Work Order ID 98182

Item Name: Crosstube Mid Fwd. Blue

DART AEROSPACE LTD HAWKESBURY, ONTARIO, CANADA	
DRAWING NO. D206-667-147	REV. A SHEET 1 OF 4
TITLE CROSSTUBE ASS'Y (206L MID FWD)	SCALE NTS

DRAWING NO. D206-667-147	TITLE CROSSTUBE ASS'Y (206L MID FWD)	REV. A	DART AEROSPACE LTD ENGINEERING ORDER		D.E.O. NO. D206-667-147-A-1	SHEET NO. SHEET 1 OF 1	SCALE NTS
DRAWN <i>q</i>	CHECKED <i>ASS</i>	MFG. APPR. <i>MB</i>	APPROVED <i>MD</i>		DE APPR. <i>MB</i>		
DATE 11.07.15	DATE 11.07.20	DATE 11.07.21	DATE 11/07/21		DATE 11.07.21

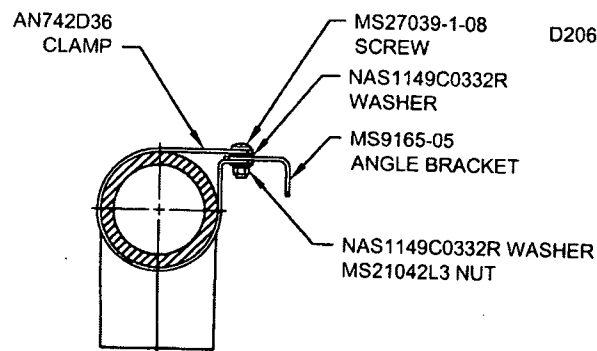
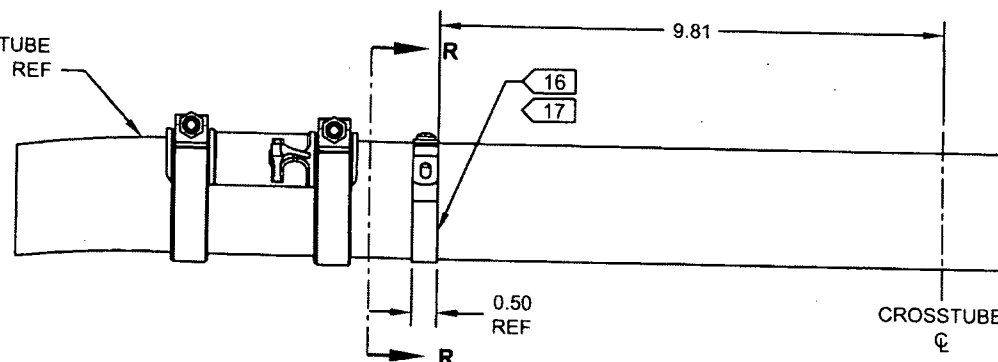
ADD ELECTRICAL GROUNDING STRAP

- 16) MASK AREA UNDER CLAMP PRIOR TO PAINTING
- 17) SEAL EDGES WHERE AN742D36 CLAMP MEETS WITH THE CROSSTUBE USING SIKAFLEX-241/-291 OR MIL-S-8802 CLASS B2 OR PROSEAL 890 SEALANT
- 18) PERFORM RESISTANCE CHECK TO ENSURE MAX RESISTANCE IS 10 MILLIOHMS
